**REQUEST FOR PROPOSAL
CITY OF ST. MARYS
NEW CITY HALL SECURITY AND FIRE ALARM SYSTEM ENHANCEMENTS**

**Addendum #1
September 17, 2026**

RENOVATION & MODIFICATION FOR
ST. MARYS CITY HALL
2603 OSBORNE ROAD
ST. MARYS, GEORGIA

SECURITY & ALARM PLAN

D-11

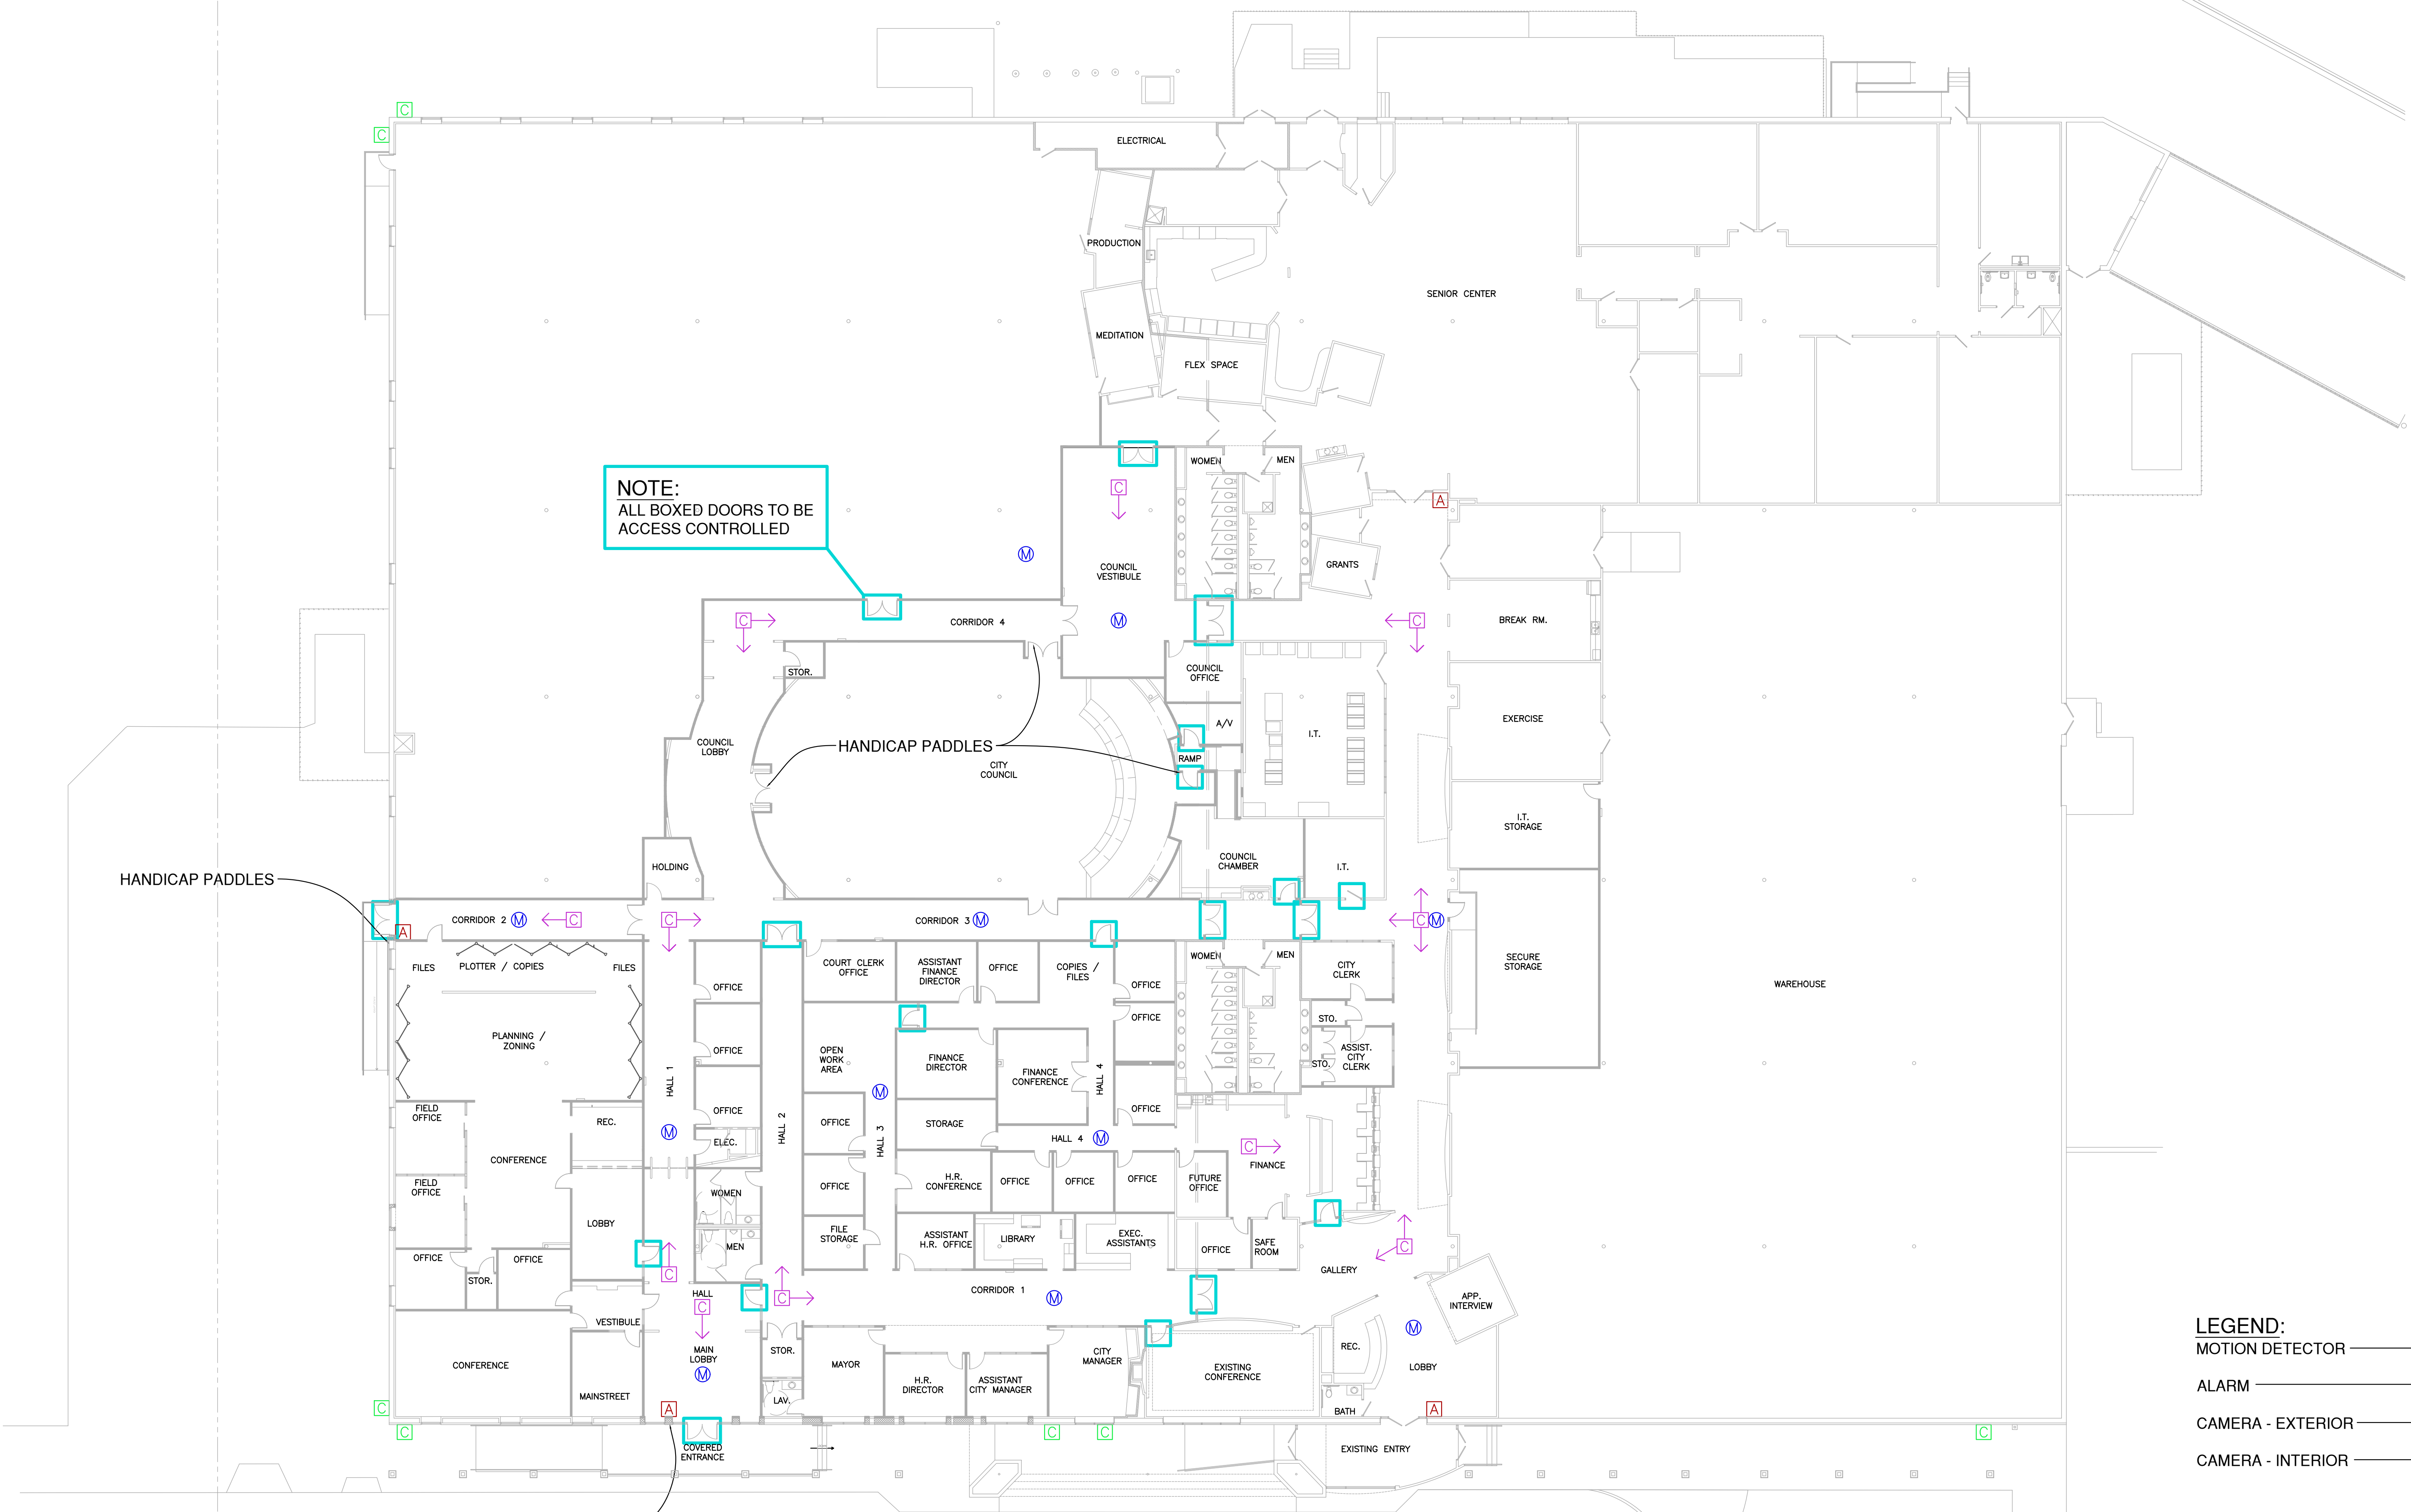
- 1) Additional Site Visit: **9:00 AM, TUESDAY, SEPTEMBER 22, 2026** @ 2603CC Osborne Rd, St. Marys, GA 31558
- 2) Drawing D-11, Security and Alarm Plan (see Attachment #1)

- 8) Are there any final device schedule, floor plans, door schedule, cable/pathway requirements, storage-retention requirements, network/PoE requirements, and addenda available after the pre-bid meeting.

ANSWER: See Attachment #1 to this Addendum.
